[Docket No. FAA-2017-0288; Product Identifier 2017-CE-007-AD]

Airworthiness Directives; Textron Aviation Inc. Airplanes

ACTION: Supplemental notice of proposed rulemaking (SNPRM); reopening of comment period.

Figure 1 to paragraphs (k)(1)(iii) and (v) of this AD: Cross section of v-band coupling

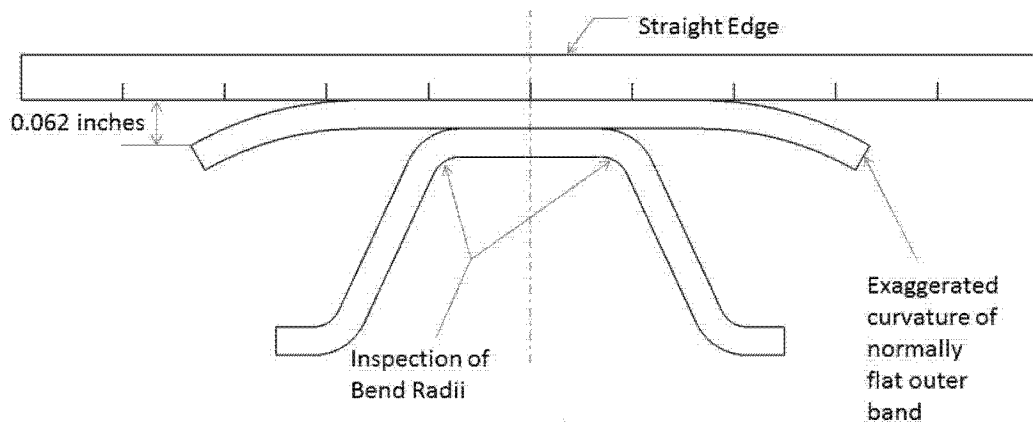
(iii) Visually inspect the flatness of the outer band using a straight edge. Lay the straight edge across the width of the outer band. The gap must be less than 0.062 inches. See figure 1 to paragraphs (k)(1)(iii) and (v) of this AD. If the gap exceeds 0.062 inches between the outer band and the straight edge, do not re-install the v-band coupling. Before further flight, you must install a new v-band coupling and restart the hours TIS for the repetitive replacement of the v-band coupling.

(v) Visually inspect the bend radii of the coupling v-retainer coupling segments for cracks. Inspect the radii throughout the length of the segment. See figure 1 to paragraphs (k)(1)(iii) and (v) of this AD. If any cracks are found, do not re-install the v-band coupling. Before further flight, you must install a new v-band coupling and restart the hours TIS for the repetitive replacement of the v-band coupling.
